Red Hill Bulk Fuel Storage Facility Informational Briefing

Honolulu City Council
Committee on Public Infrastructure,
Technology and Sustainability Meeting
January 23, 2019

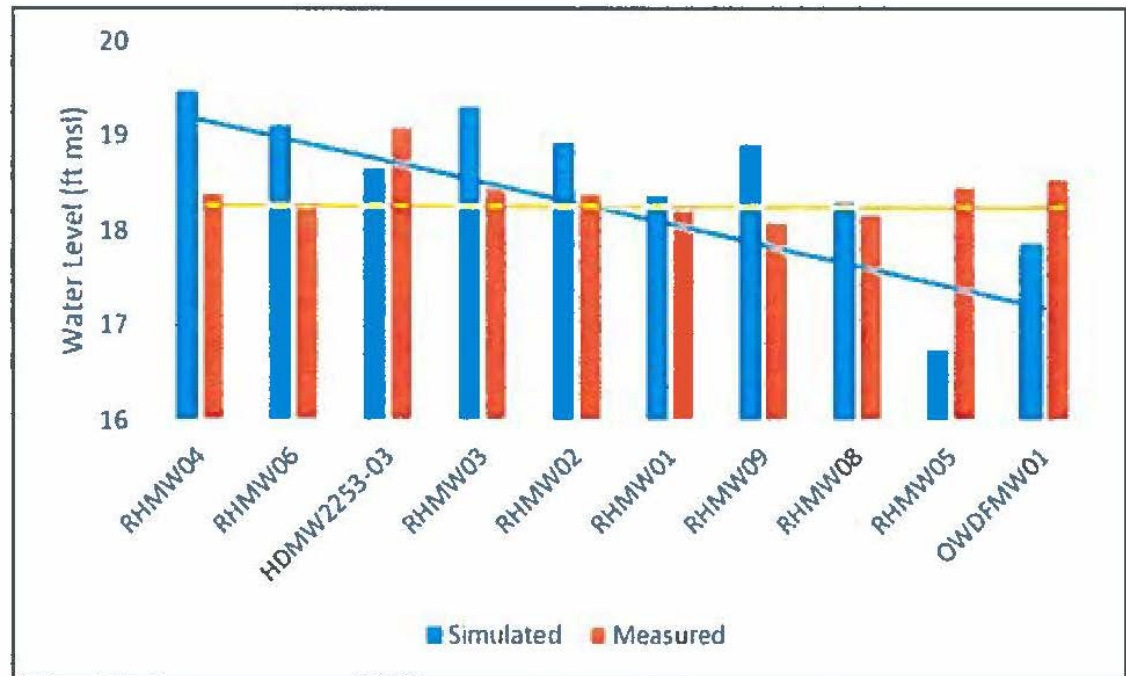
Navy Interim GW model calculation of groundwater levels at Navy monitoring wells (blue line) does not match with measurements collected in the field (yellow line)

BWS: Lack of correlation between observed and model simulation means the model is not calibrated. This is a fundamental requirement of a good model and it's ability to produce reliable results. DOH and EPA share this same concern.

∴ Model not calibrated.
